A D D E N D U M

Project No.: 2501101
Project: EACS Restroom Renovations

Addendum No: 02
Date: 04/02/2025

ADDENDUM NO. 02, to Drawings and Specifications dated 03/12/2025, for the EACS Restroom Renovations for the East Allen County Schools; as prepared by ELEVATUS Architecture, 111 E. Wayne Street, Suite 555, Fort Wayne, IN 46802

PROJECT NO. 2501101
ISSUE DATE March 12, 2025
SUBMITTAL Issue for Bids, Permits, and Construction
Electrical Information Sheet

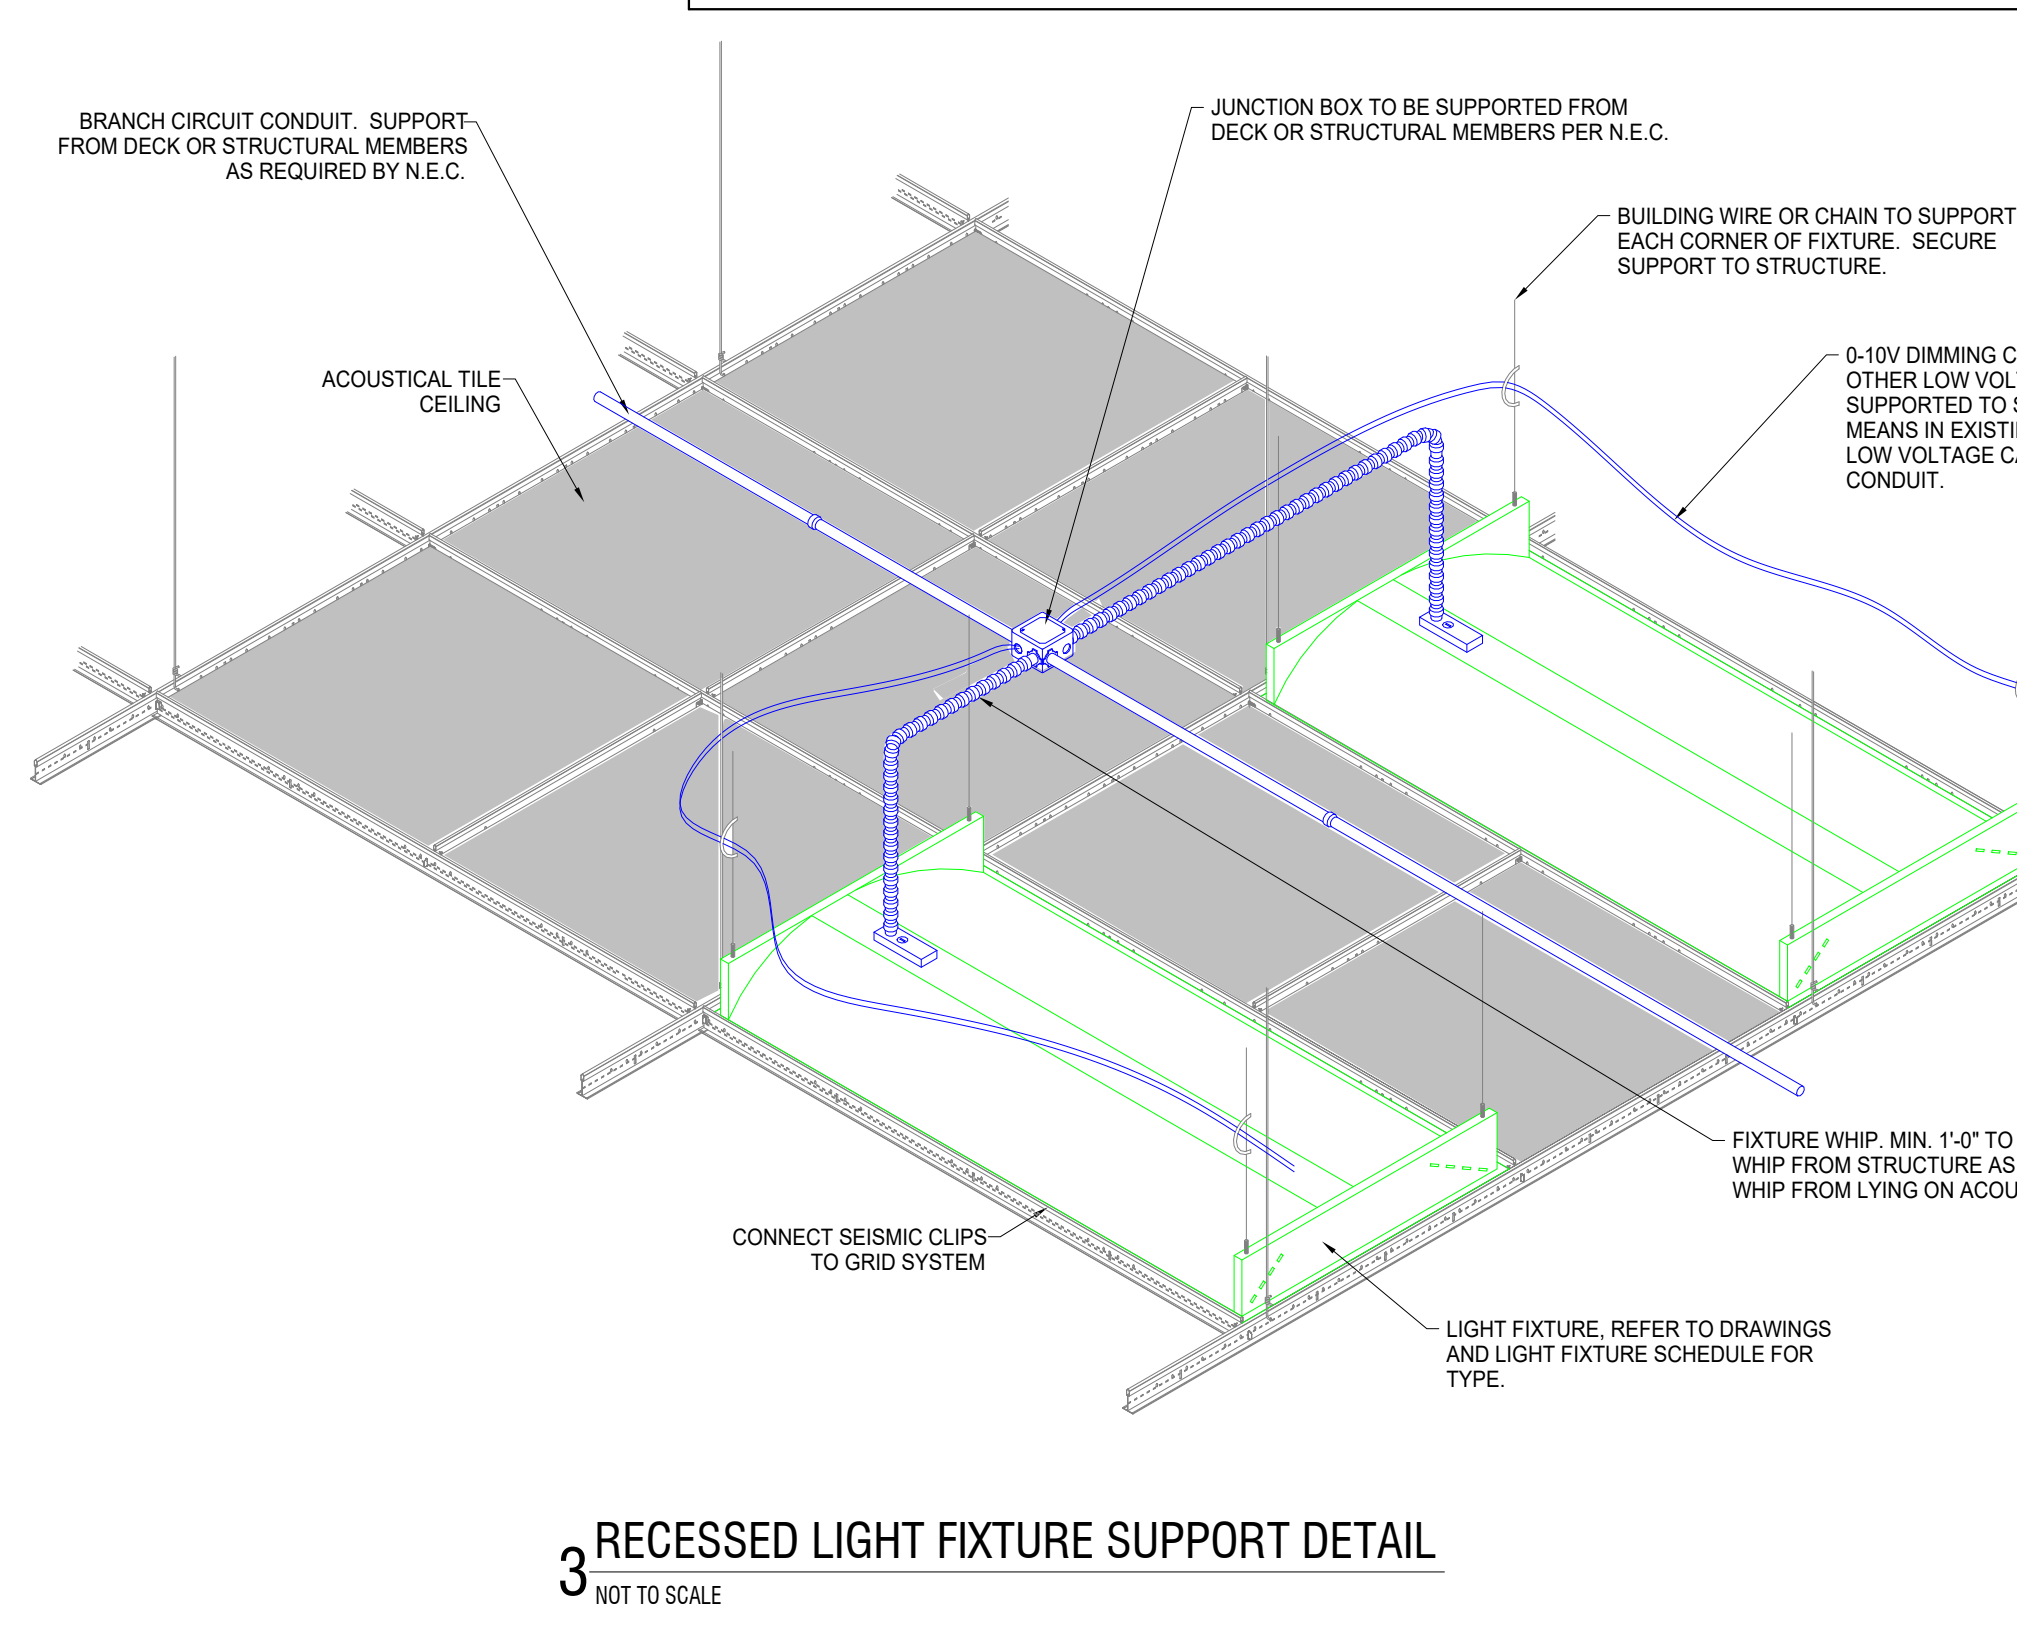
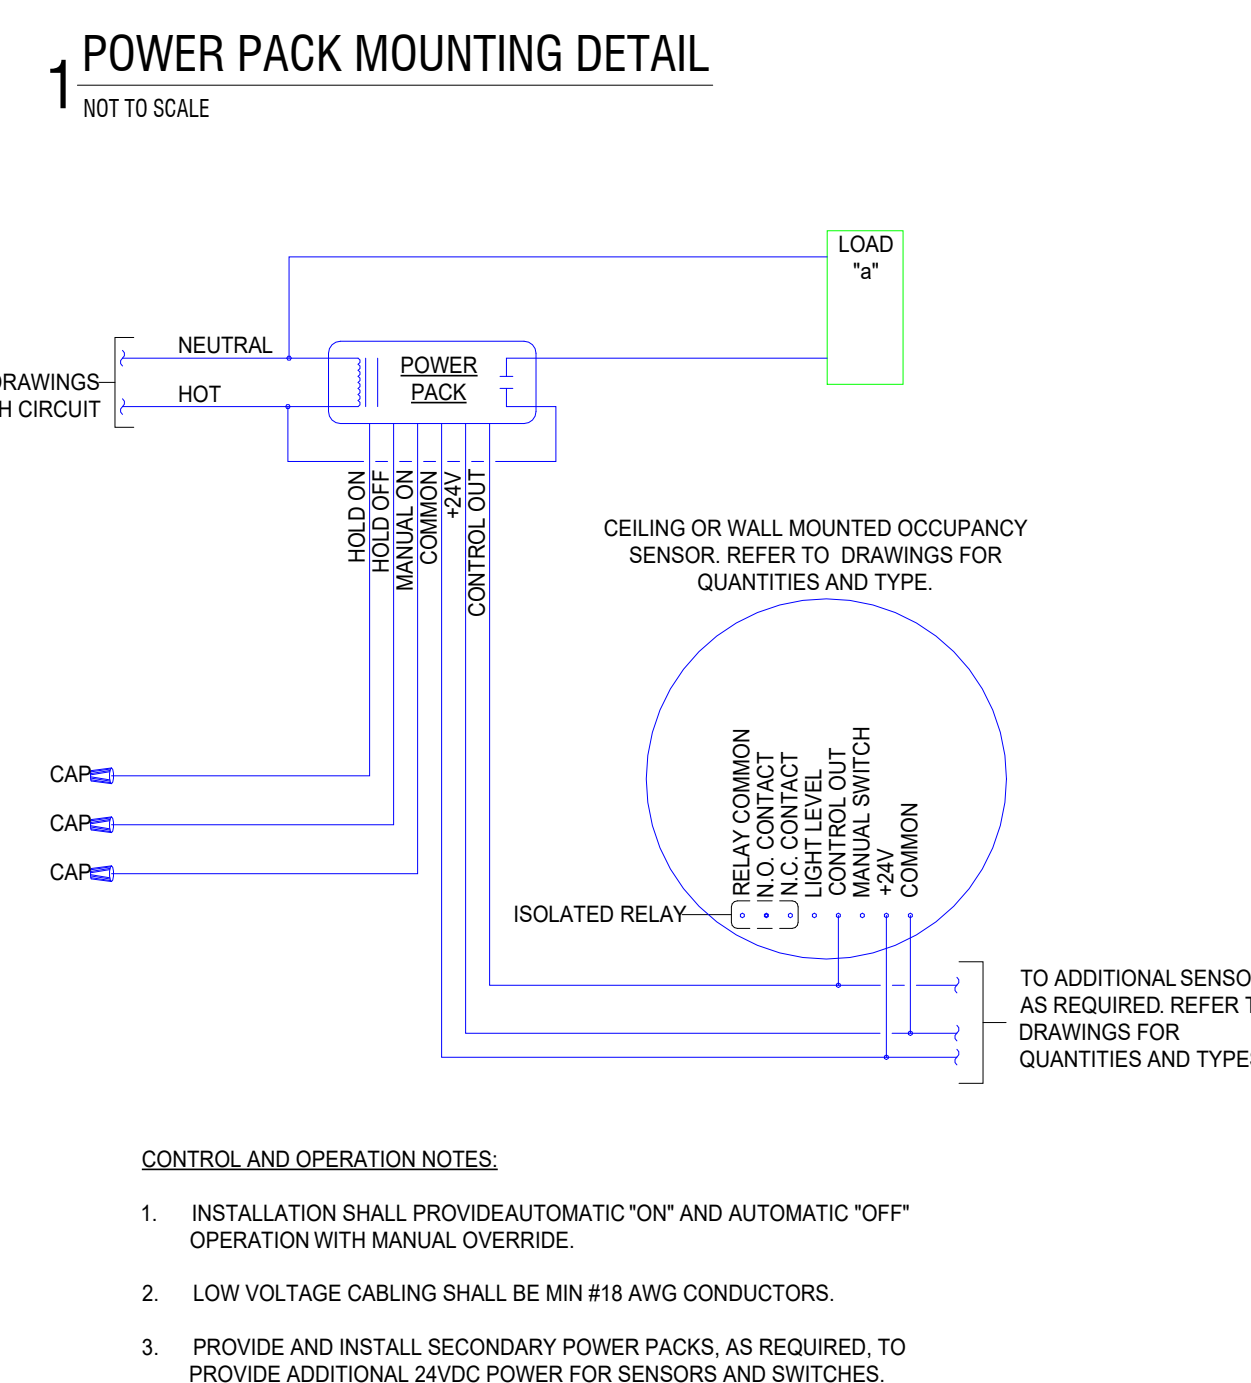
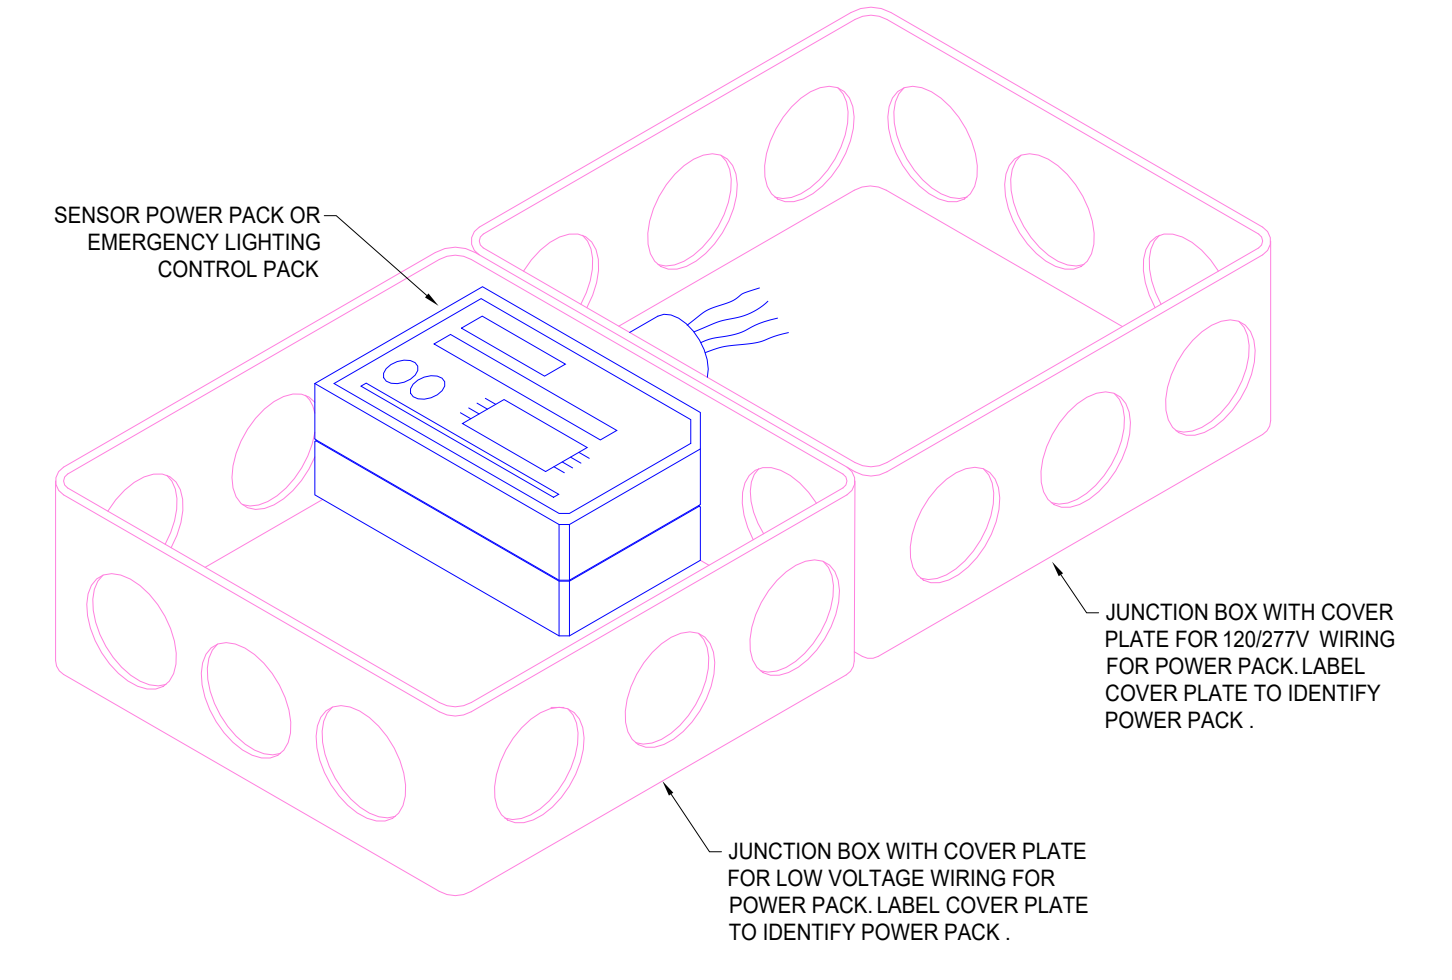
Item #1: Heritage HS: Drawing Sheet E001, "Electrical Information Sheet":

- A. Revise Light fixture schedule. Added HALO #H277 step down transformer as required for 120v connection to wafer downlight fixture, as required. Refer to drawing sheet E001 labeled Addendum #2 for more information.**
